REMARKS

Application No. 10/723,658 Response to Office Action

Amendments to the Drawings:

Figs. 6-14 have been amended to remove the reference numerals $\dot{}$ 60, 62 and 70 and the lead lines thereof.

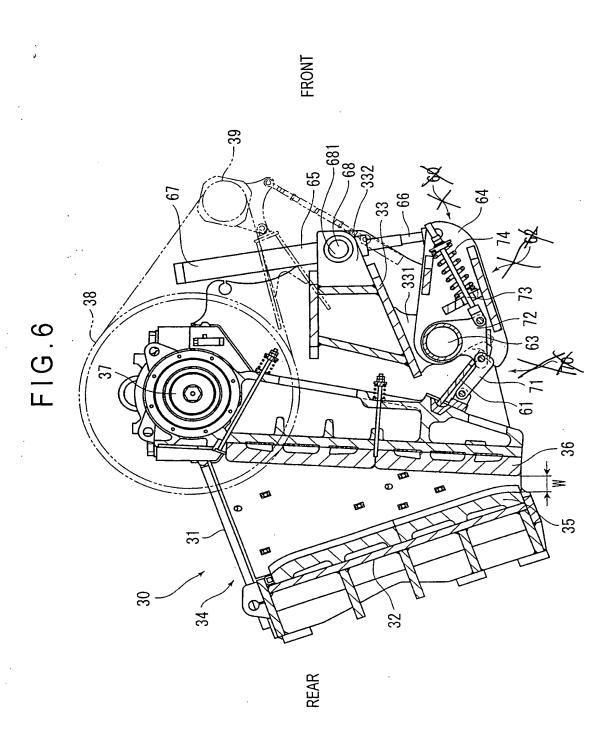
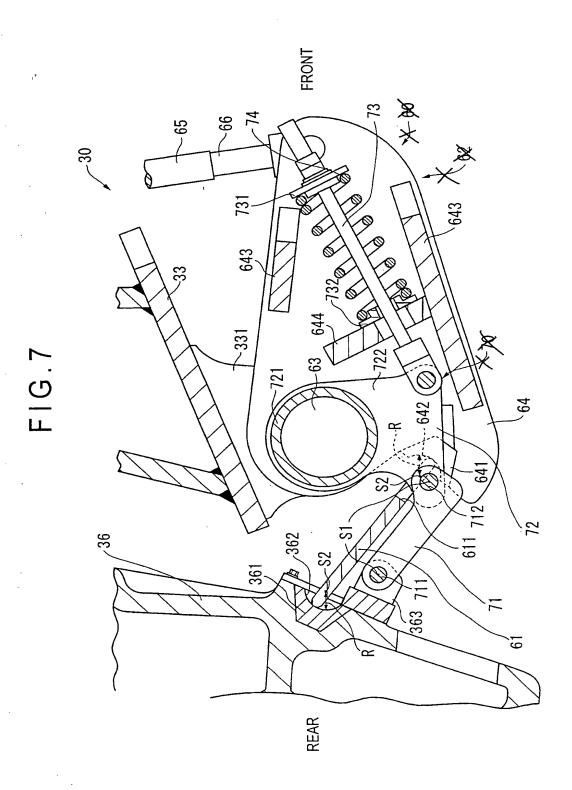
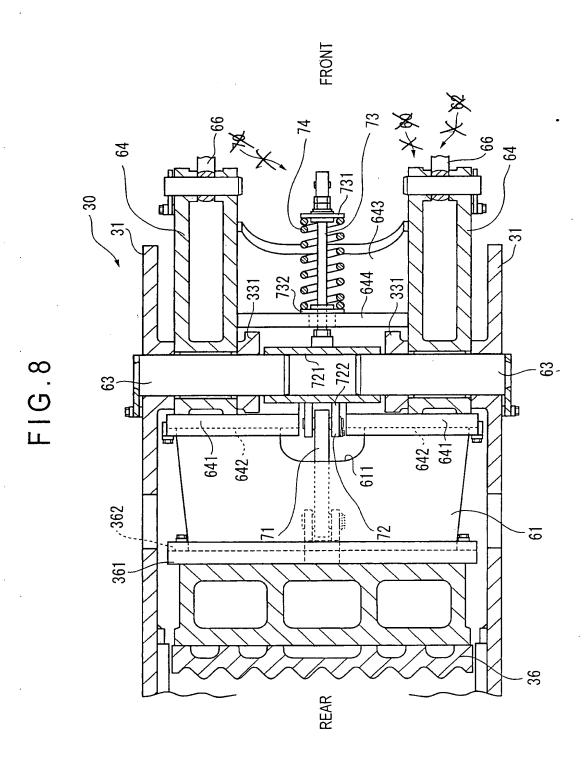
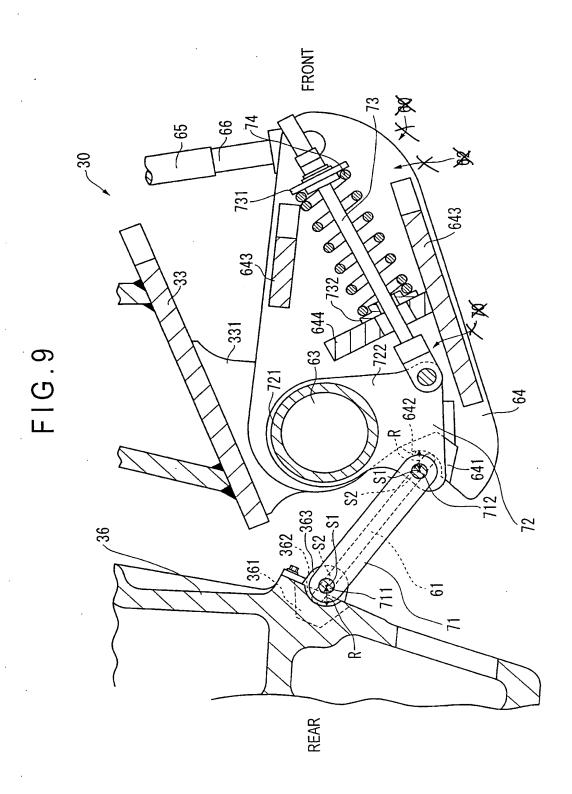
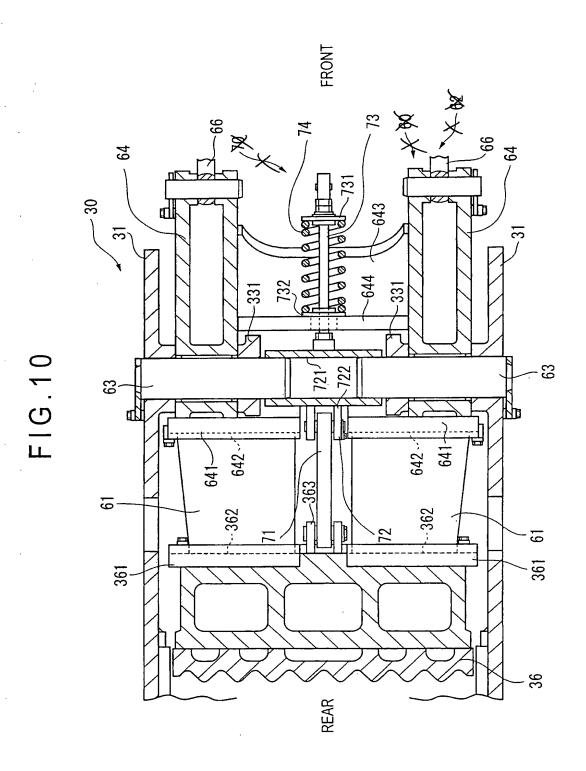
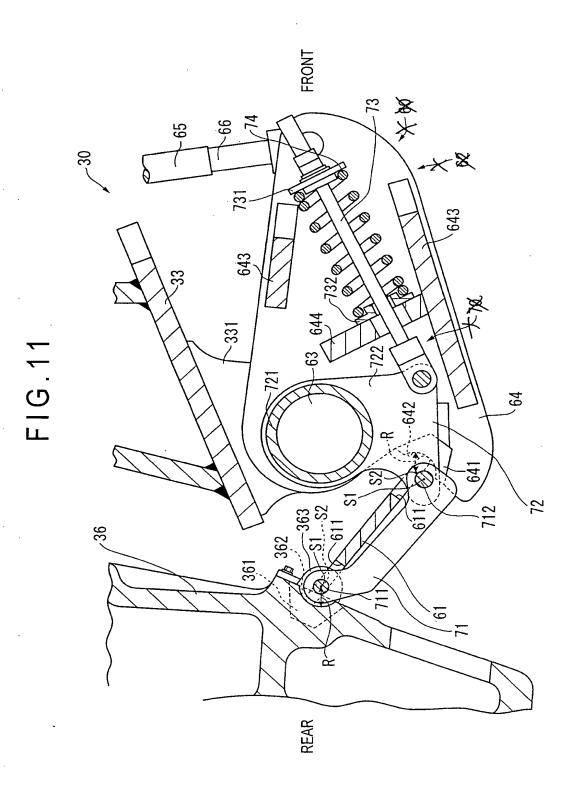
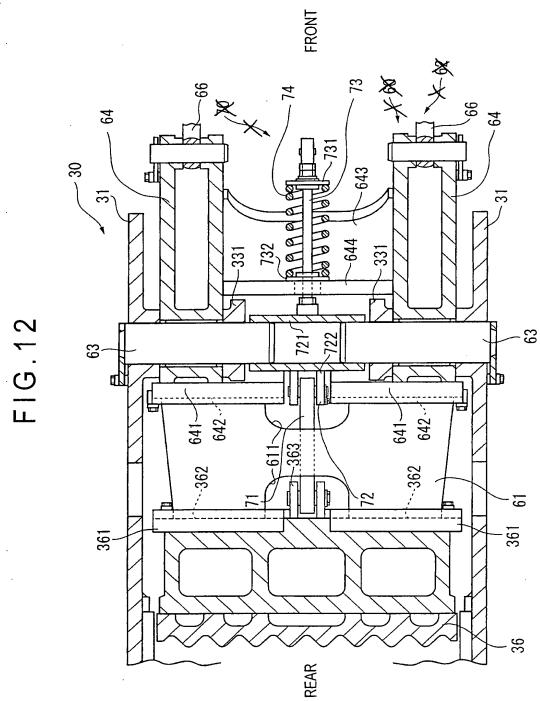
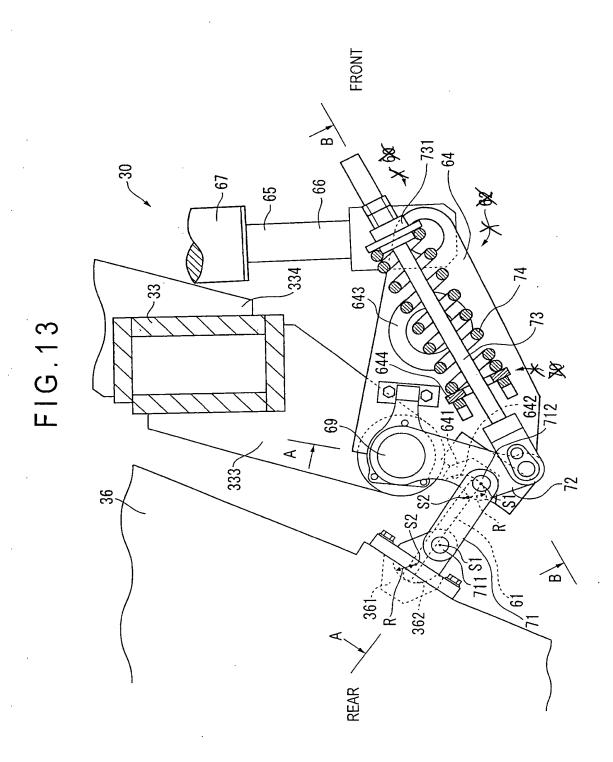
Figs. 6-14 have been amended to remove reference numerals 60, 62 and 70.

Submitted herewith are corrected sheets of formal drawings which incorporate the amendments and annotated sheets showing the changes made thereto.
